39T-14506/Z-8436
Nancy Pasato

TO:	CHAIR AND MEMBERS PLANNING AND ENVIRONMENT COMMITTEE
FROM:	GEORGE KOTSIFAS, P.ENG. MANAGING DIRECTOR, DEVELOPMENT & COMPLIANCE SERVICES AND CHIEF BUILDING OFFICIAL
SUBJECT:	APPLICATION BY: ZELINKA PRIAMO LIMITED PORTION OF 3105 BOSTWICK ROAD and BLOCK 172, 33M-562 TALBOT VILLAGE PHASE 5 & 6 MEETING ON MAY 19, 2015

The purpose of the recommended action is to consider a redlined draft plan of subdivision containing 244 single detached lots, 1 school block, 1 park block, 1 road widening, and 2 - 0.3 m reserves, all served by the extension of Old Garrison Boulevard (a secondary collector), 2 secondary collectors and 8 new local streets along with the appropriate zoning for these lands.

Submitted Draft Plan of Subdivision

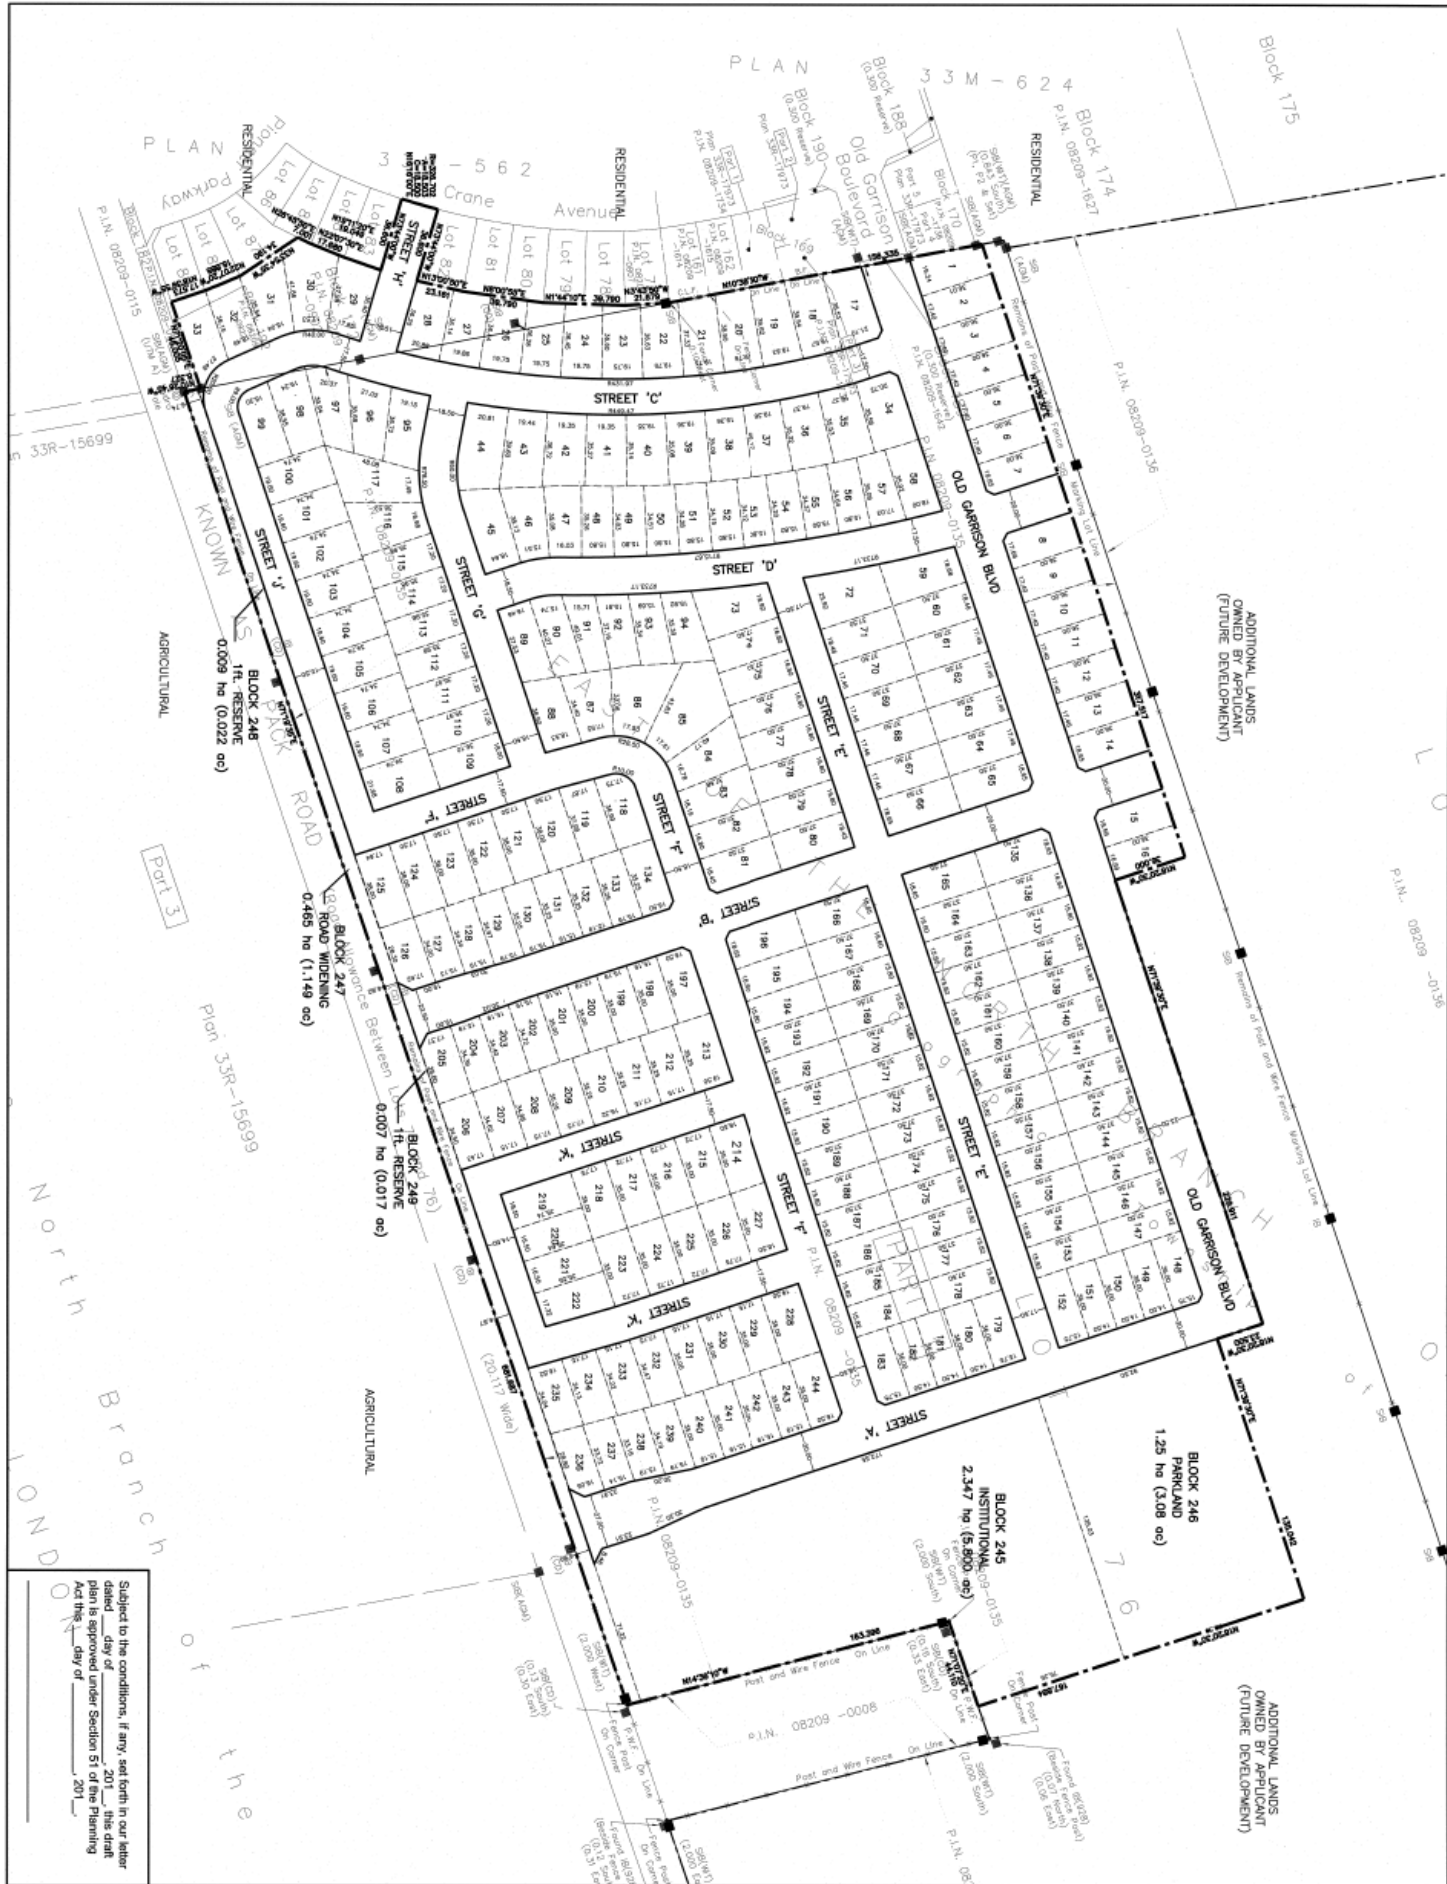
As part of the initial draft plan circulation, the Thames Valley District School Board (TVDSB) requested that a school block be added to this draft plan of subdivision. The other school block previously allocated for a school is currently being developed by the French Public School Board (Conseil Scolaire Viamonde). The Applicant has since revised the draft plan to include a school block, located to the east of Street A and adjacent to Pack Road.

The North Talbot Community Plan allocated a school site to the north of this subdivision; however, the Applicant has indicated that the parcel to the north is not owned by the current Applicant. In order to provide a school site, the Applicant has added it to additional lands owned by the Applicant on the east side of Street A north of Pack Road. From a planning perspective, the proposed school block is still centrally located and will be able to service the North Talbot Community. The TVDSB has indicated that the previously allocated site to the north is adjacent to the square, which presents a problem with respect to accessibility and safety for students. Comments provided by the TVDSB indicates they prefer the school block as submitted by the Applicant, as it is easily accessible by major roads and is adjacent to City park. Although this school block does not meet the location within the Community Plan, staff support this new location.

As part of the Community Plan process, a park is to be located on the east side of Street A, adjacent to the future square about. Through the original subdivision application, no park land was proposed for the subject site, and Parks Planning requested cash in lieu of parkland. However, since the request for the school block from the TVDSB, the Applicant has revised the plan to include a portion of the City park. The location is in keeping with the North Talbot Community Plan. The subdivision is slightly under dedicated (0.065 ha) after the dedication of the park, so it is expected that this parkland will be taken in future phases of North Talbot.

Proposed Red-line Plan

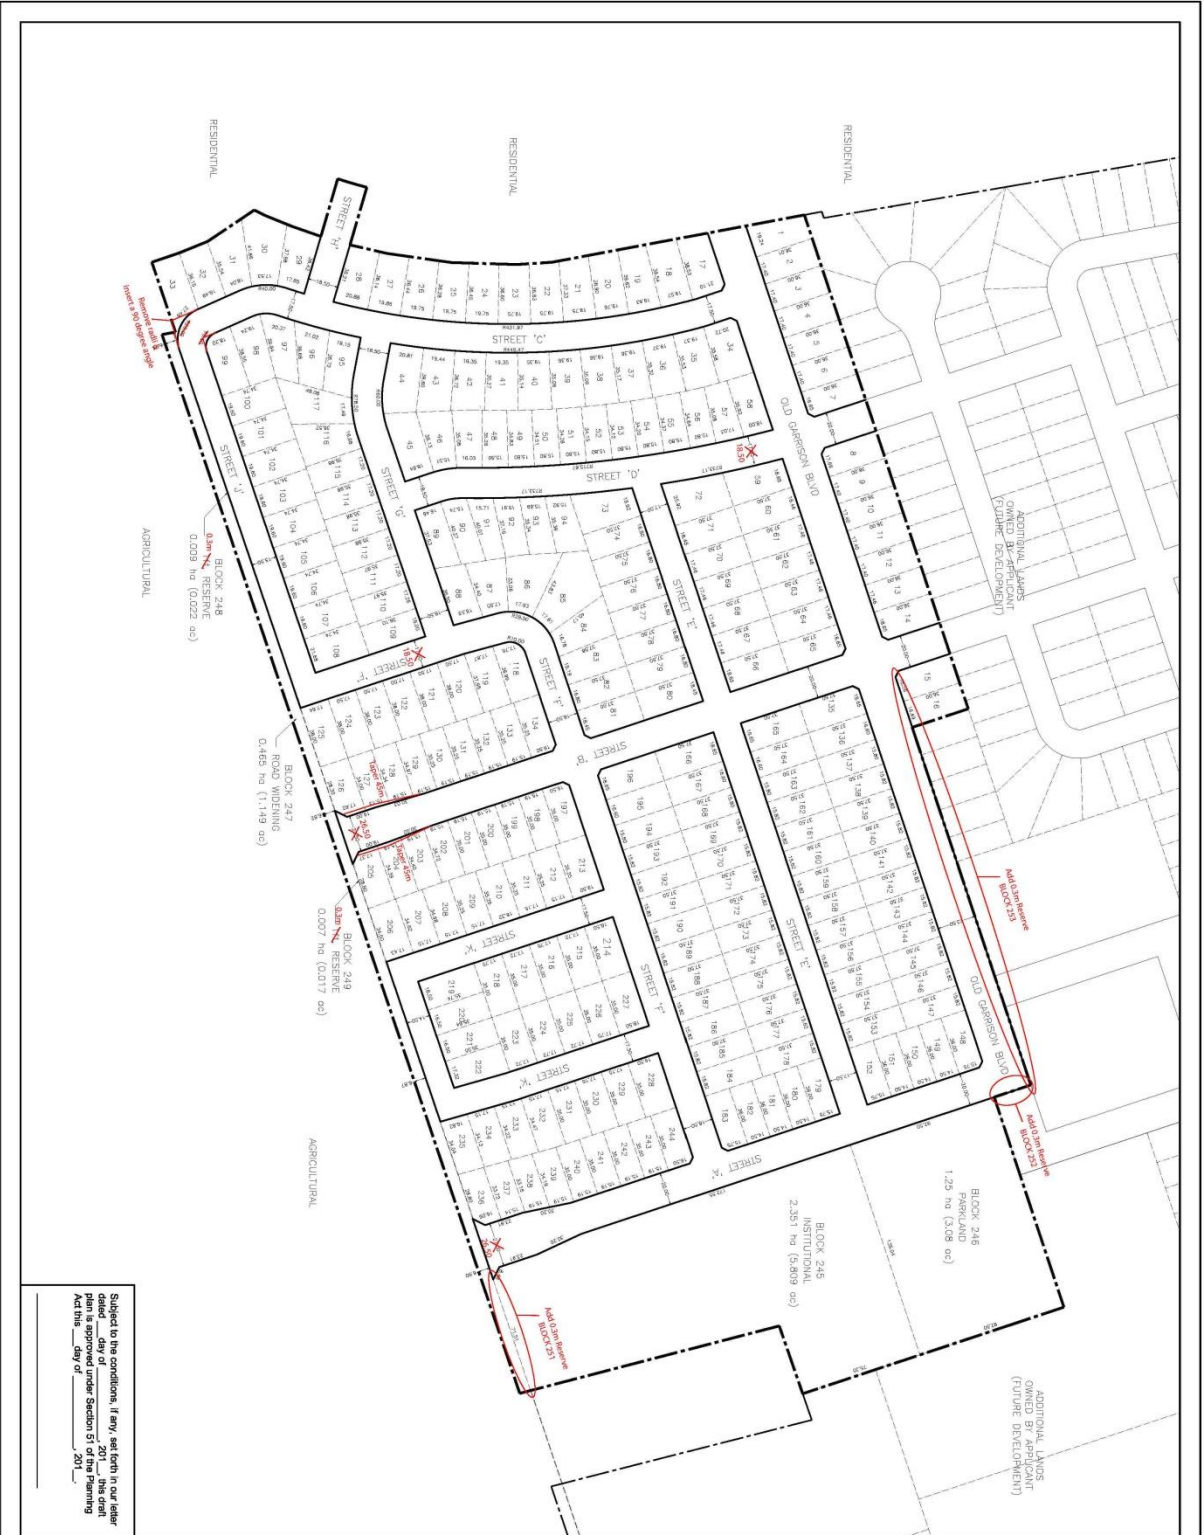
In addition to several changes to Blocks that have been noted throughout the report, a number of redline changes have been made to the draft plan. The following is a list that sets out some of those changes. The more substantial changes have been explained in various sections of this report and have not been noted in the below list:

- Provide a right-of-way width to the following:
 - a) Streets ‘A’ and B’ shall have a minimum right-of-way of 20.0 m;
 - b) Streets ‘D’ shall have a minimum right-of-way of 18.5 m;

- c) Streets ‘A’ and ‘B’ at the intersections with Pack Road with a right-of-way width of 26.5 m for a minimum length of 45.0 m tapered back over a distance of 30 m to the standard secondary collector road right-of-way width of 20.0 m, to provide a Subdivision Entrance Treatment.

- Provide 0.3 m reserves as per the following:
 - a) Along the entire frontage of Pack Road adjacent to Lots 235 and 236 and Block 245 with the exception(s) of Street ‘A’, ‘B’ and sidewalk connections from the window streets;

- b) Along the entire east limit of Street ‘A’ adjacent to Old Garrison Boulevard;
 - c) Along the north boundary of Old Garrison Blvd. (from Lot 16 to the east limit of this Plan);

- d) Along the north limits of this Plan on Streets ‘B’ and ‘D’.
- The radius bend connecting the proposed Street ‘C’ and ‘J’ shall be removed and revised, perpendicular to Pack Road fronting Lot 33 (see redline plan attached).
